SUBJECT: Supplemental Information for the Texas A&M University AGN-201M reactor
License Application

MODIFICATION AUTHORIZATION

Title: AGN Reactor Console Instrumentation and Electronics Upgrade

Safety Evaluation of the AGN Reactor Console Instrumentation and Electronics Upgrade

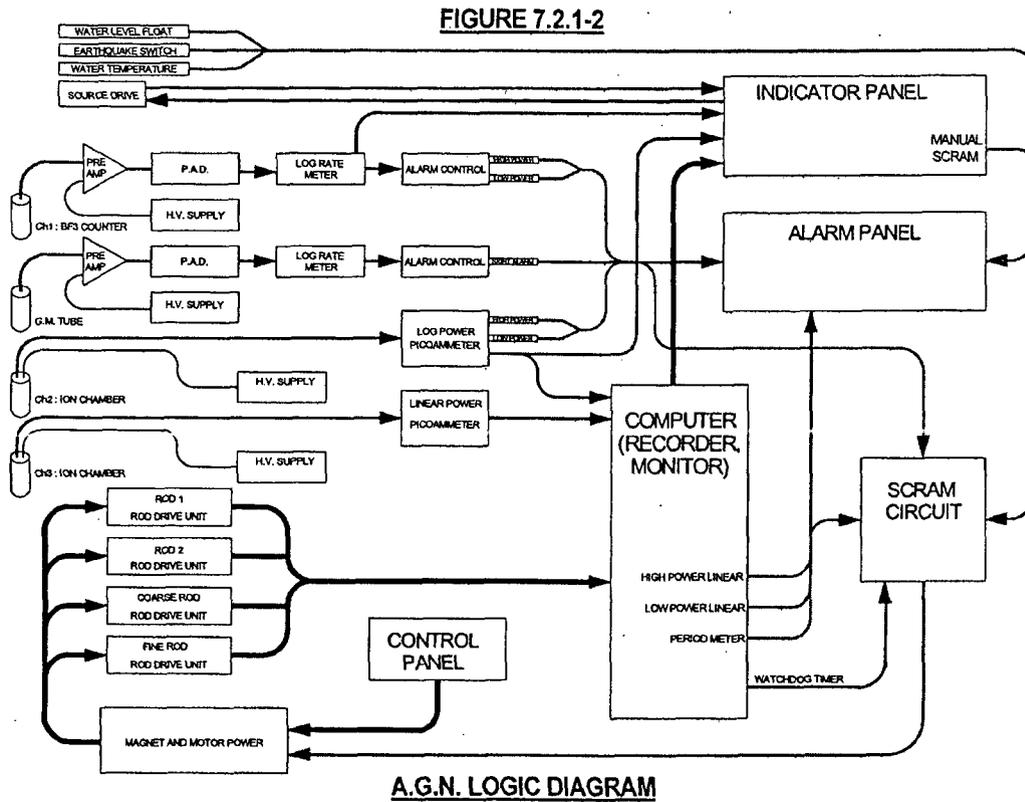
As shown in the following figure, the logic is the same as in the old console except a computer used as digital recorder and monitor. The scram circuit is designed to trip the reactor immediately when the computer fails. The signals from some channels will bypass the computer and actuate the scram directly so that the safety redundancy is maintained.

Figure 7.2.1-2 NUCLEAR INSTRUMENTATION SYSTEM

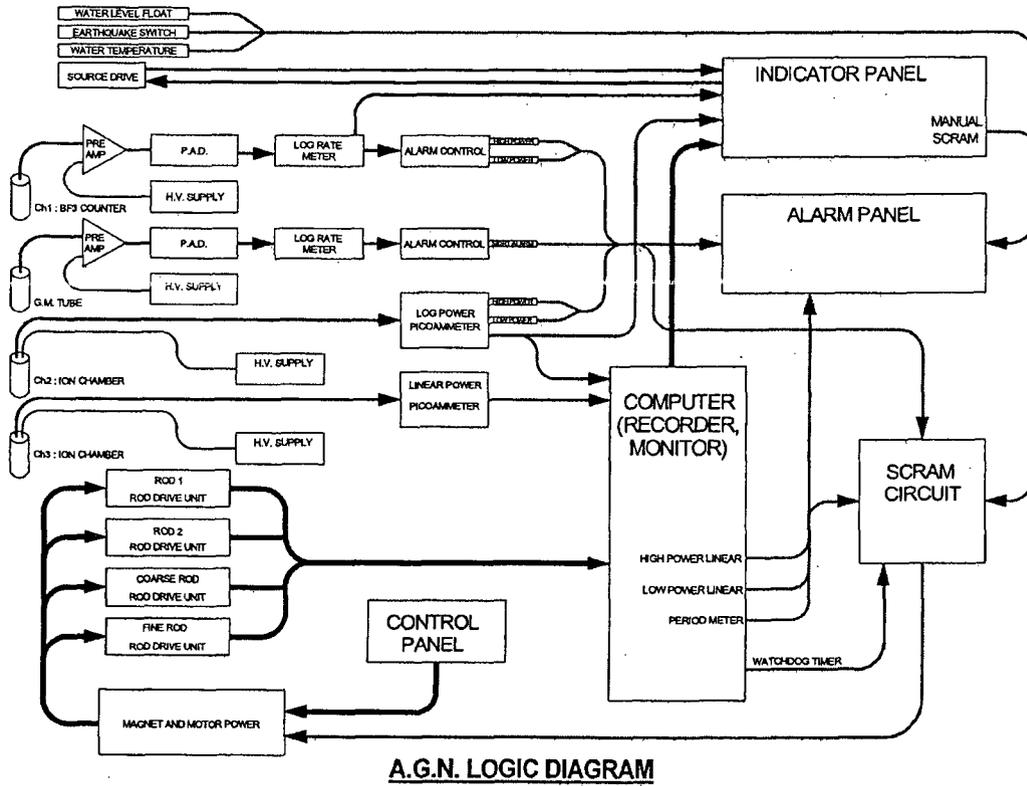
No FSAR and Tech. Spec. modification has been made with the exception of two instrument displays (not functionality). Subsequent console appearance and model name have been replaced in FSAR Chapter 7 as attached in Appendix B. No safety evaluation for the FSAR changes is needed.
